Access Compliance Report

Public Rights-of-Way

Intersection ID: 48197	Main Street: BLAKENEY_PARK_DR	Cross Street: ARDREY_KELL_RD	Location: SE
ADA ID: 46C13E4247A3	Ramp Type: BlendTrans1	Initial Pass/Fail: Fail	Overall Compliance: No
Severity Score: 12.5			
Codes/Mitigation Info/Possible Solution		Field Measurements/Component Compliance

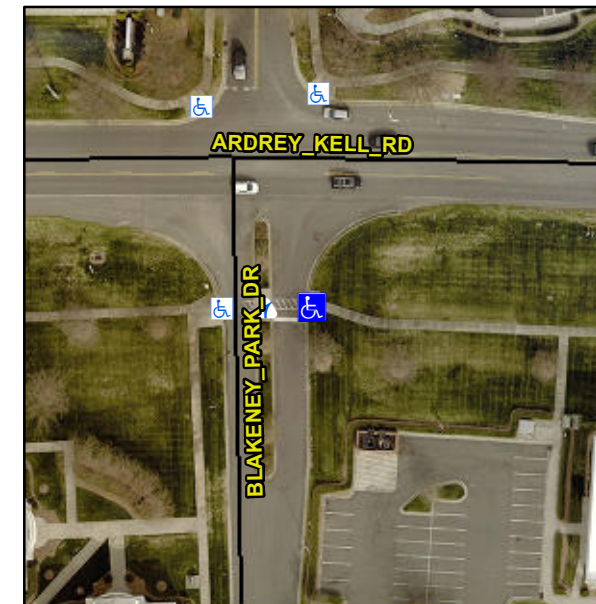
Not Found, R304.5.3

Compliance	Description	Data	Compliance	Description	Data
N/A	Ramp Length (in)	61.0	Yes	BlendTrans Slope (%)	2.8
Yes	Ramp Width (in)	57.0	No	BlendTrans XSlope (%)	6.2
N/A	Flare Type LT	N/A	N/A	Flare Type RT	N/A
N/A	Flare Slope LT (%)	N/A	N/A	Flare Slope RT (%)	N/A
N/A	Flare Traversable LT?	N/A	N/A	Flare Traversable RT?	N/A
N/A	Landing Length (in)	N/A	N/A	DWS Provided?	N/A
N/A	Landing Width (in)	N/A	N/A	DWS Contrast?	N/A
N/A	Landing Slope (%)	N/A	N/A	DWS Length (in)	N/A
N/A	Landing X Slope (%)	N/A	N/A	DWS Full Width?	N/A
N/A	Landing Curb? (Y/N)	N/A	N/A	DWS Offset (in)	N/A
N/A	Shared Landing?	N/A			
N/A	Gutter Ponding?	N/A	N/A	Gutter Slope (%)	N/A
N/A	Gutter Lip Ht (in)	N/A	N/A	Gutter X Slope (%)	N/A
N/A	Painted X Walk1?	Yes	N/A	Painted X Walk2?	N/A
	X Walk 1 Direction	To W		X Walk 2 Direction	N/A
	X Walk 1 Width (in)	52.0		X Walk 2 Width (in)	N/A
	X Walk 1 Slope (%)	0.9		X Walk 2 Slope (%)	N/A
	X Walk 1 X Slope (%)	4.4		X Walk 2 X Slope (%)	N/A

N/A	Ramp inside XWalk1?	Yes	N/A	Ramp inside XWalk2?	N/A
	Road Slope (%)	4.4		Clear Space?	N/A
	Road X Slope (%)	0.9	N/A	Clear Space to XWalk (in)	N/A
N/A	Any Obstructions?	N/A	N/A	Storm Grate/Utility Hazard?	N/A
	Obstruction Type			Storm Grate/Utility Type	
		N/A			N/A
			Yes	Surface Condition? (G/P)	Good
			No	Curb Slope (%)	7.1

Remove & Replace Curb Ramp With Two New Directional Ramps or Equivalent.
